# SERVICEMEDDELANDE SERVICE MESSAGE

E 93 - 1 to 7

The Service Messages number 93 - 1 to 7 are not applicable to the edition of the Service Manual printed in 1958.

## Adjustment of cooling fan clearance

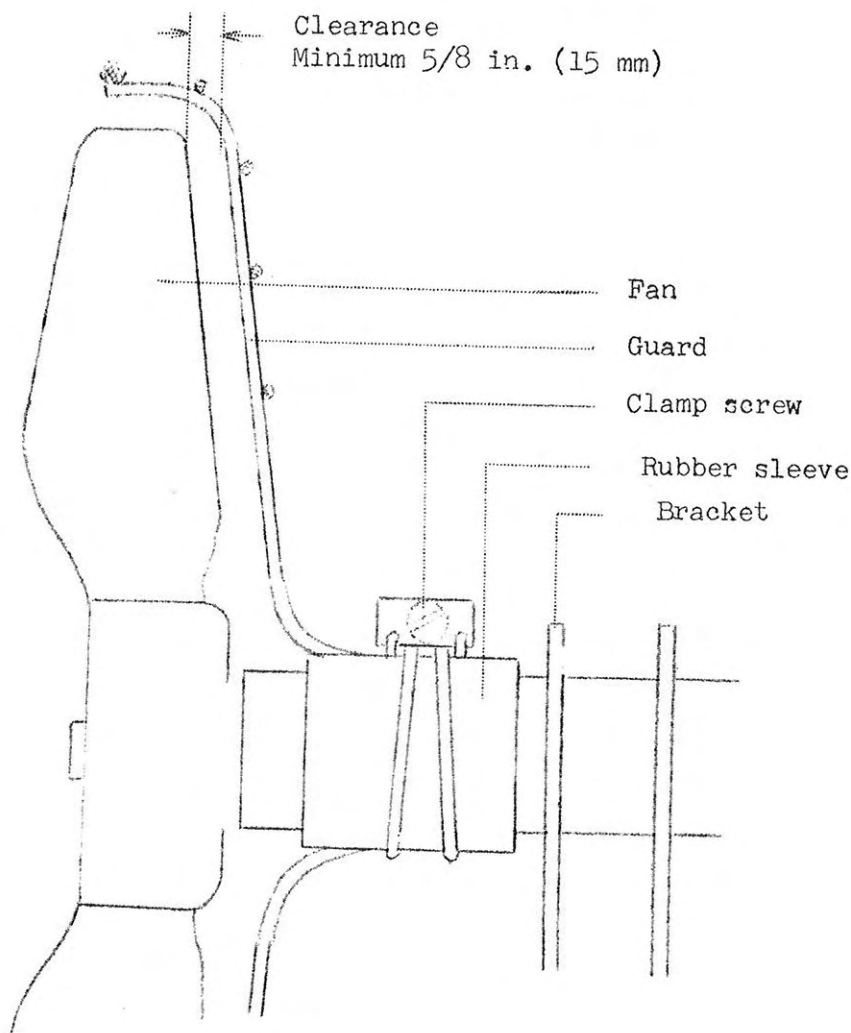
In order to avoid damages to cooling fan and its guard the fan clearance should be checked when servicing cars. If adjustment be required loosen the clamp screw and push the guard and rubber sleeve forward against the bracket. As shown in figure below the clearance should be at least 5/8 in. at the tip of all fan blades. If these measures prove to be insufficient, the edge of the guard may be bent slightly forward until correct clearance is obtained.

## Modification of gear lever return spring

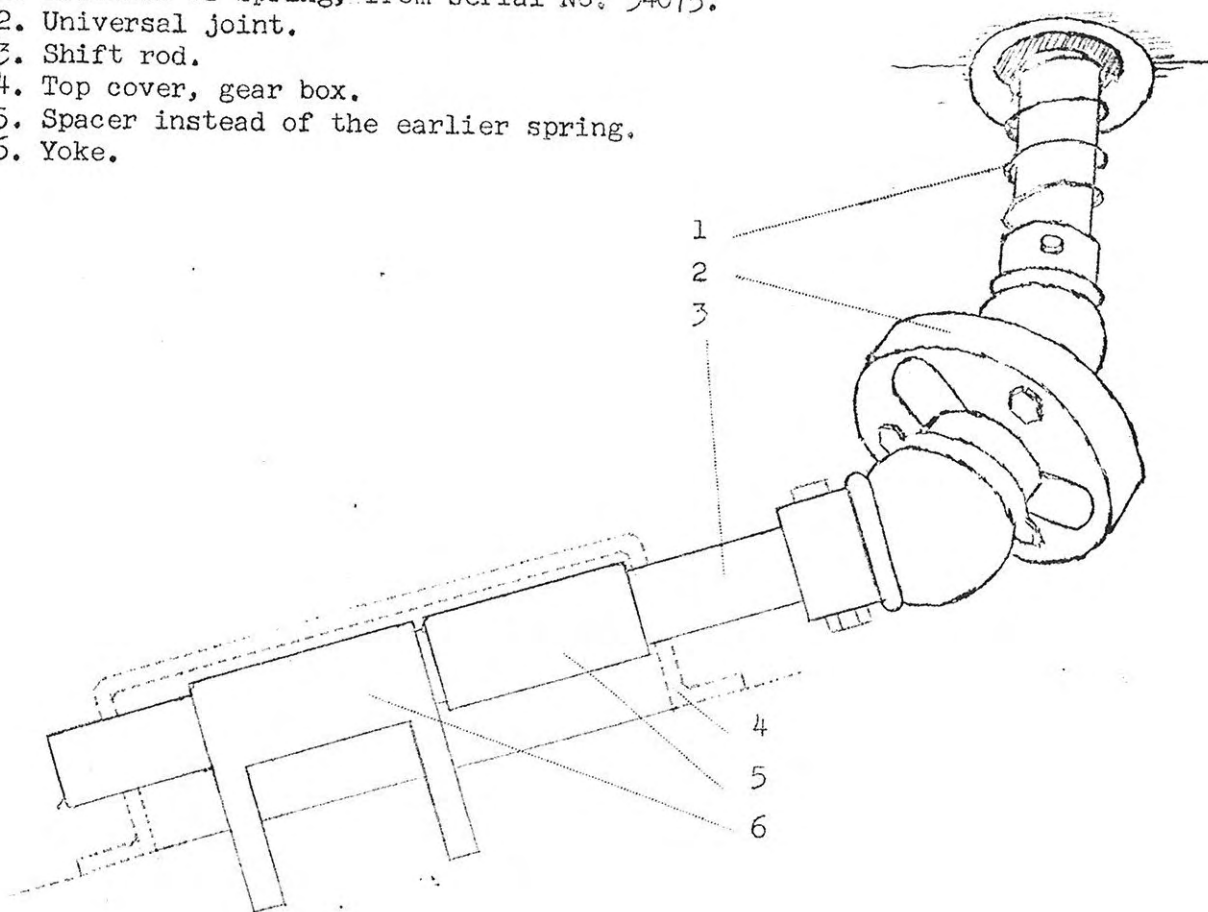
From serial number 34075, the above mentioned spring is modified. The earlier spring (spare part No. 707418), which is cylindric and placed on the shift rod in the gear box top cover, is replaced by a spacer and a new conical spring (710514) has been fitted on the gear shift rod between the universal joint and the firewall, see fig. The reason for this modification is to reduce transplantation of noise from the gear box.

If a gear box or any part in the gear shift mechanism is to be changed be sure that only one of the return springs is mounted and preferably the one outside the gear box. In case the spring inside the gear box is to be removed, remember to put a spacer, 5, in its place on the shift rod.

1. Location of spring, from serial No. 34075.
2. Universal joint.
3. Shift rod.
4. Top cover, gear box.
5. Spacer instead of the earlier spring.
6. Yoke.

## Modified gear box components

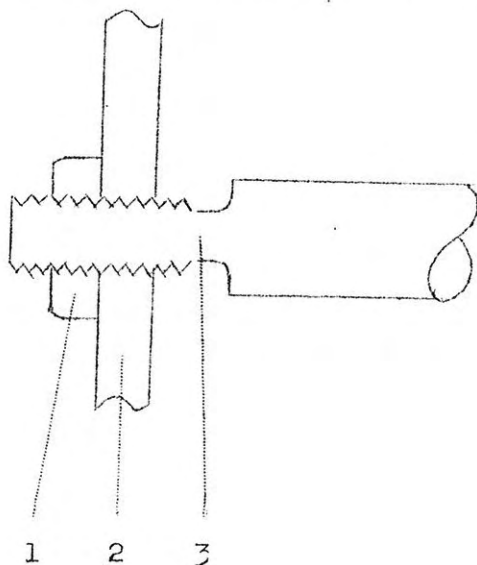
The screw for adjustment of the 2nd - 3rd speed gear shift bar is from serial number approx. 32000 (gear box 32601) integral with the gear shift bar, (see fig. below) and the coil spring at the front end of the bar has been removed. The adjustment of gear shift bar is carried out in the same way as before. - (Service Manual. Chapt. 3 item 4.2.6.2.) As the gear shift bar now will come loose when dismantling the gear box end cover, exercise great care so as not to lose the ball catch and its spring, which are fitted in the gear shift fork.

1. Lock nut
2. Gear box end cover
3. Gear shift bar

## Ignition timing - modified distributor

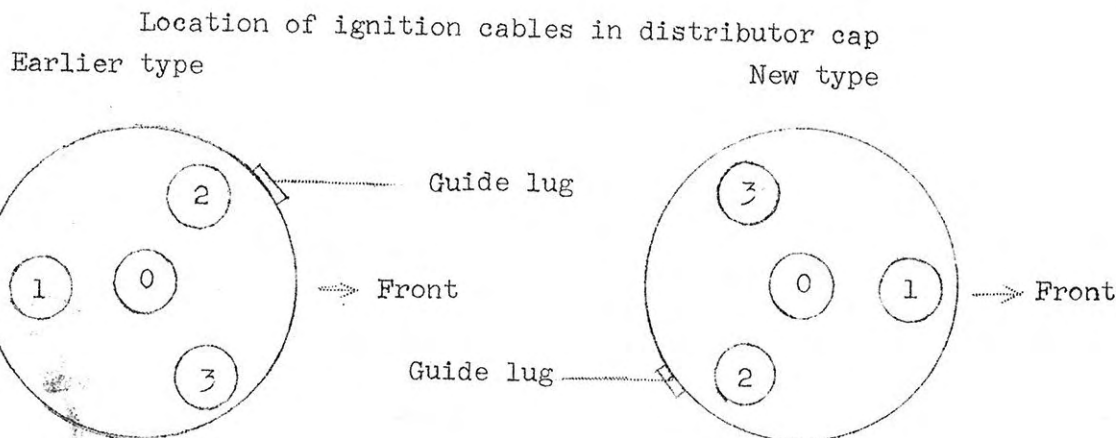
From engine number 39639 (serial number approx. 38300) the ignition distributor is modified and its cap is guided by a lug on the rear clamp spring bracket, i.e. it is turned 180°. Thus the ignition cables are now positioned as shown in the figs. below. The condenser and primary cable terminal are situated on the rear side of the distributor body, and the protective cover under the rotor is removed. In consequence of these modifications the marking on the distributor for ignition timing is now situated to the left of the rear spring clamp bracket, i.e. the guide lug. When the piston in cyl. no 2 is at its TDC the rotor should thus point rearwards, which is quite contrary to the instructions issued concerning the earlier type of distributor. The two different procedures for timing the ignition must not be confused, which is important especially when a distributor is re-installed after having been dismantled.

## Gearbox - Needle bearings for 2nd speed drive

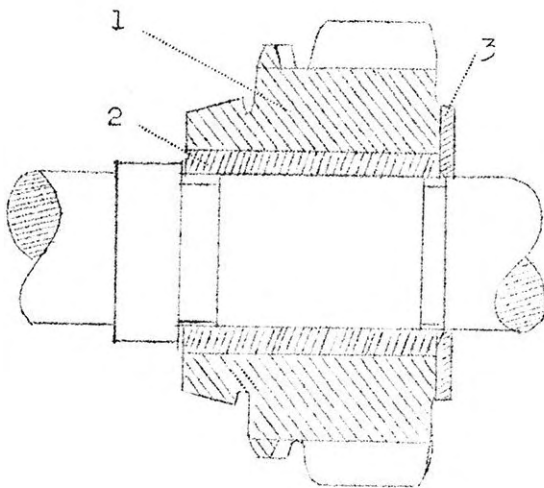
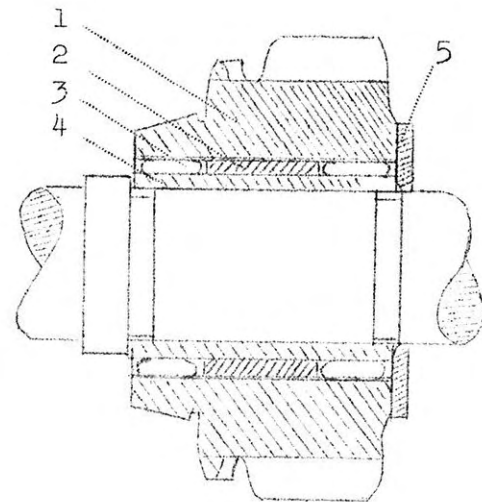
From serial number approx. 42200 (gearbox no. 44511) the 2nd speed drive on the main shaft is equipped with two needle bearings. The bearings are fitted between a new, thinner steel bushing and the modified drive gear. Between the bearings there is a spacer.

Fig. 1. To gearbox no. 44510.

Fig. 2. From gearbox no. 44511.

Fig. 1. The power unit as seen from below. - The distance between lever and wire attachment bracket should be 86 mm  $\pm$  2, (3.3/8  $\pm$  3/32 in.).

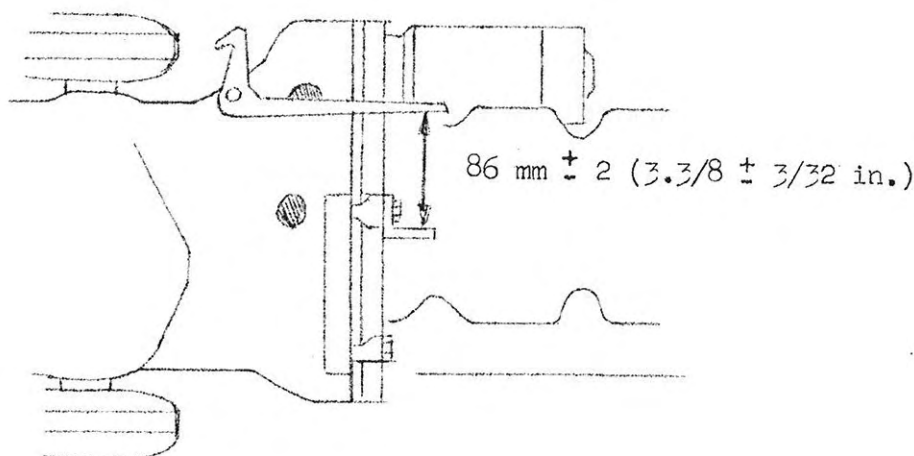
Should the new type of light metal casing be fitted to an earlier type of gearbox, it is necessary to check and adjust the position of the release lever as per fig. 1 below.

The distance between the release lever and wire bracket indicated in fig. 1 should be correct, when the lever is forced away from the bracket until there is no play between the release bearing and release plate.

Note. This instruction is also applicable to the earlier design of gearbox and should be checked, especially if any release mechanism part, e.g. the release bearing, is replaced. Adjustment of the lever is carried out by bending it carefully until the desired shape is obtained.
